S/T. "LORD PLENDER".

Proposed Rudder.

TO ACCOMPANY LIV. Rpt. No. 156350  
(FTWOOD)

SUBJECT:- Rudder plan (app. Sld).

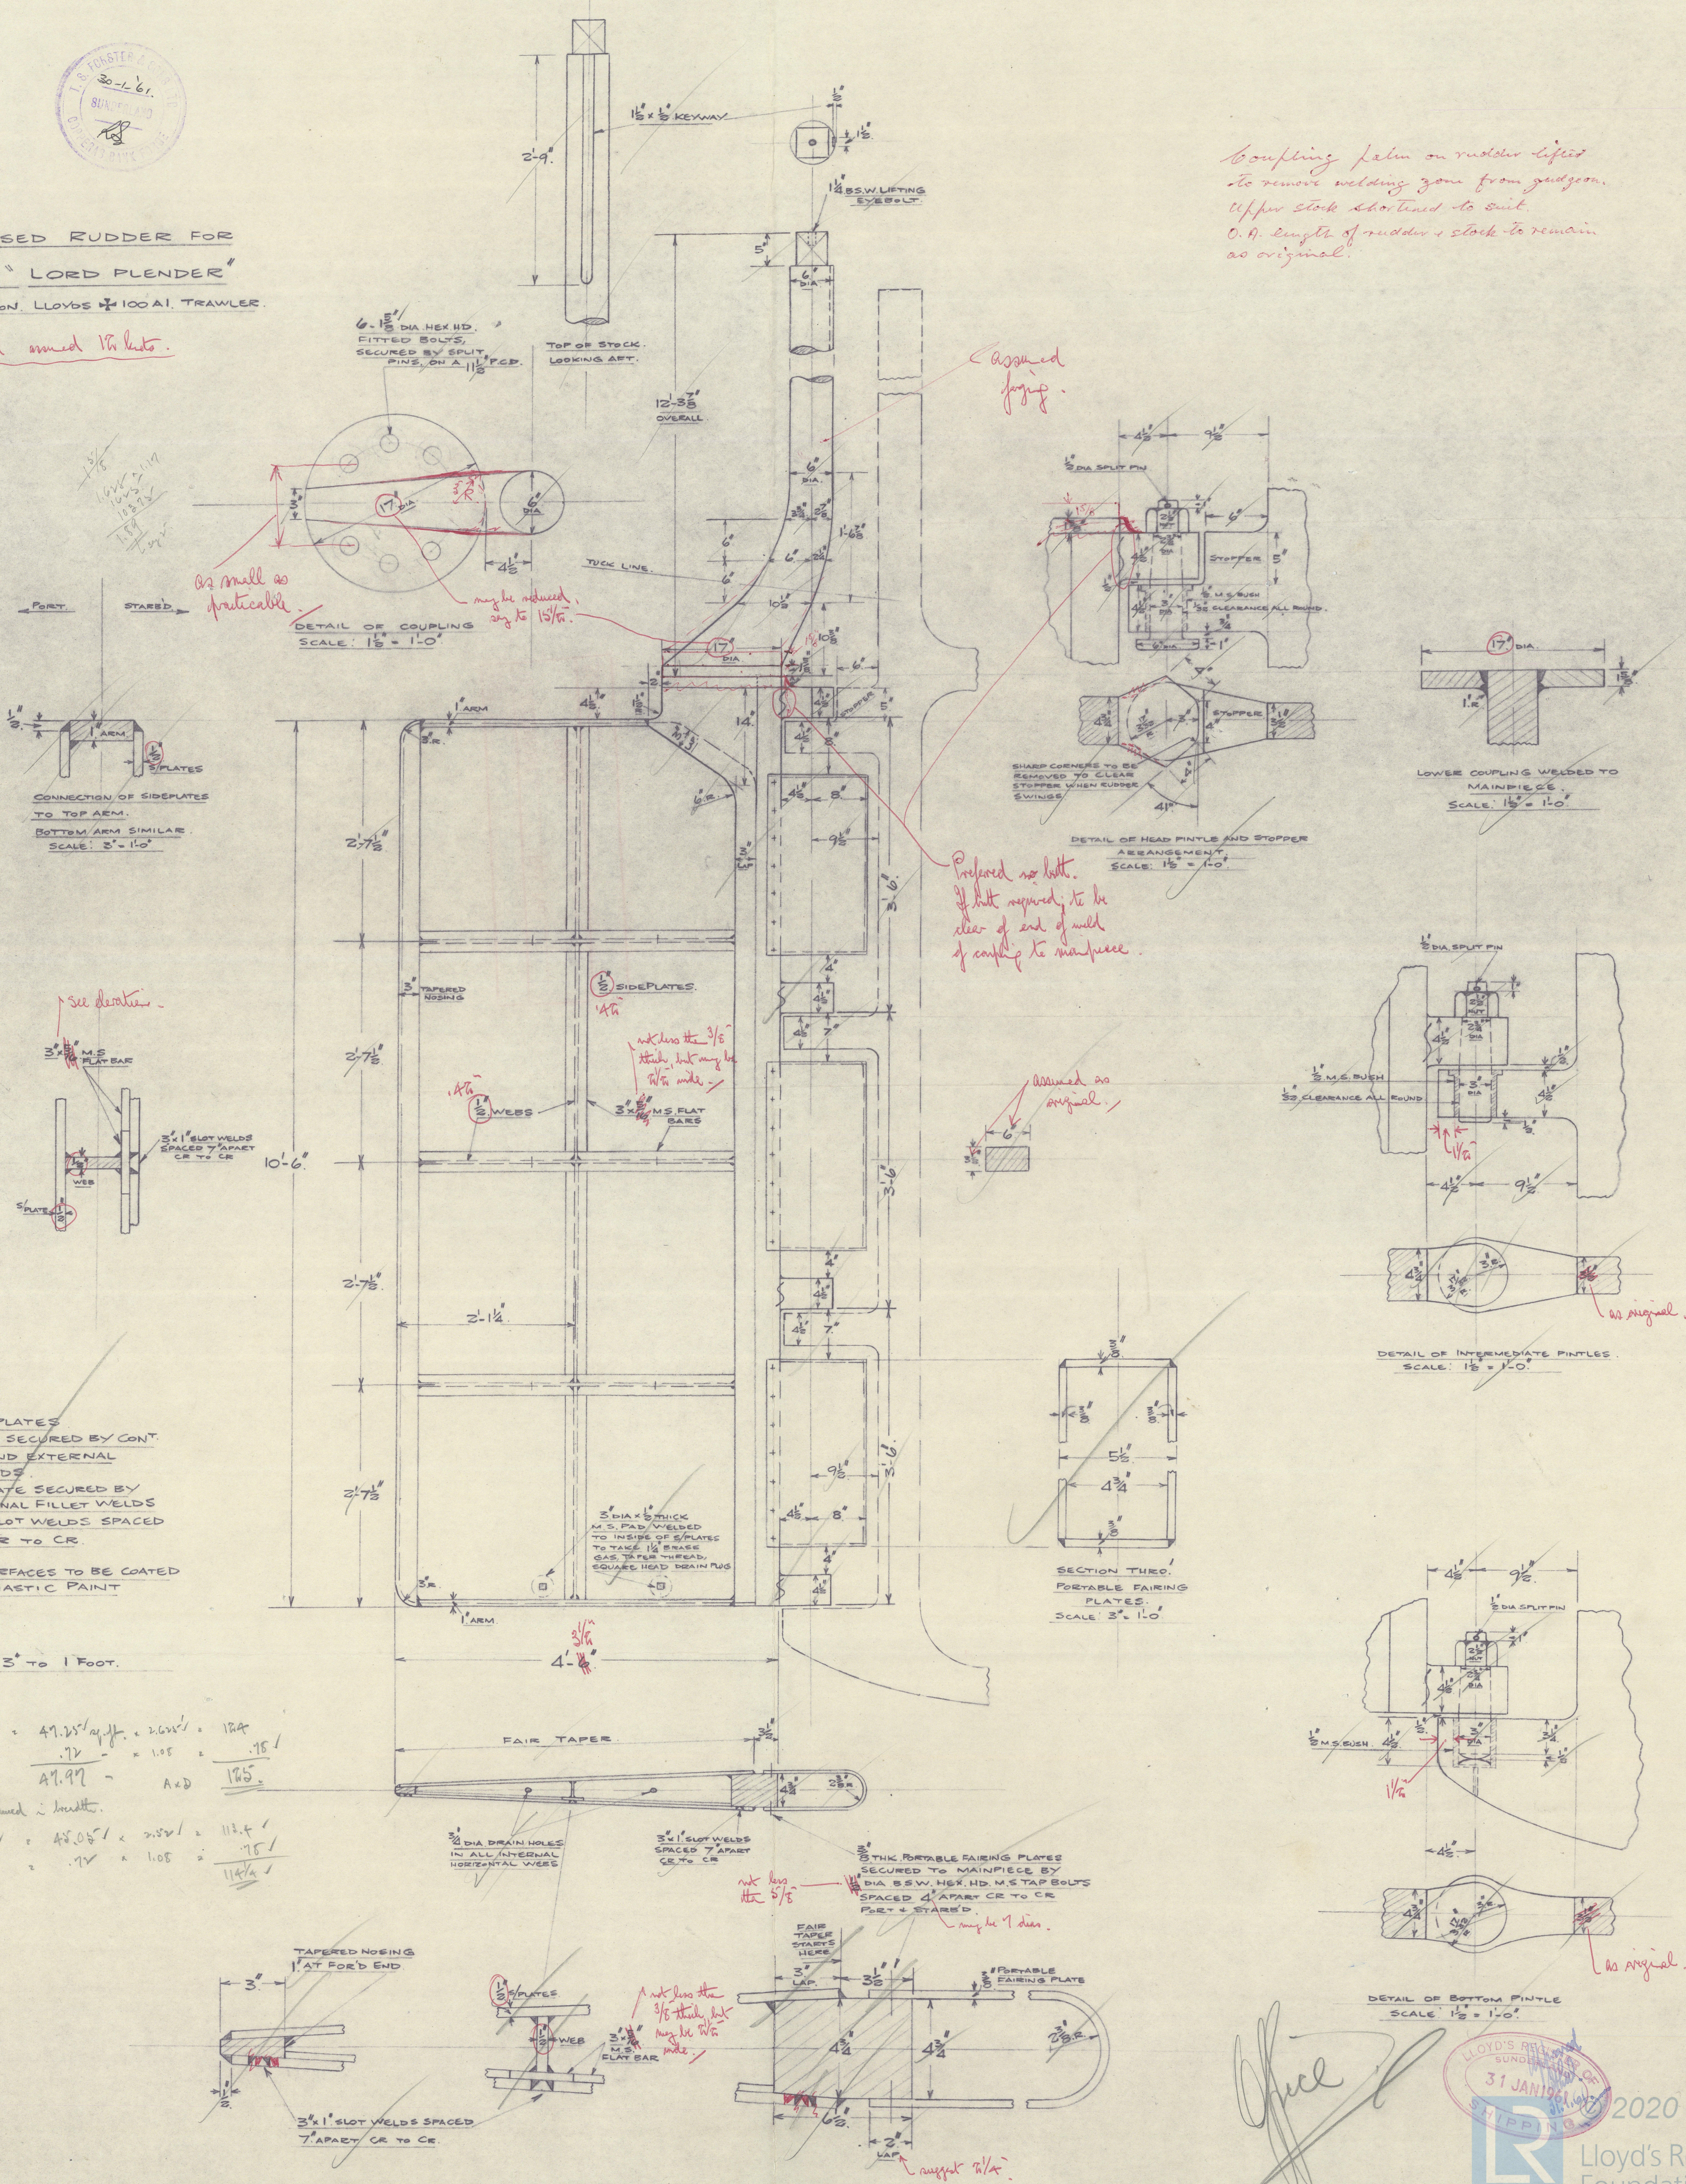
Sea Speed assumed 17 knots.

Coupling Palm on rudder lifts  
to remove welding zone from gudgeon.  
Upper stock shortened to suit.  
O. A. length of rudder & stock to remain  
as original.

- Preferred no butt.  
If butt required; to be  
clear of end of weld  
of coupling to main piece.

Assumed as original.
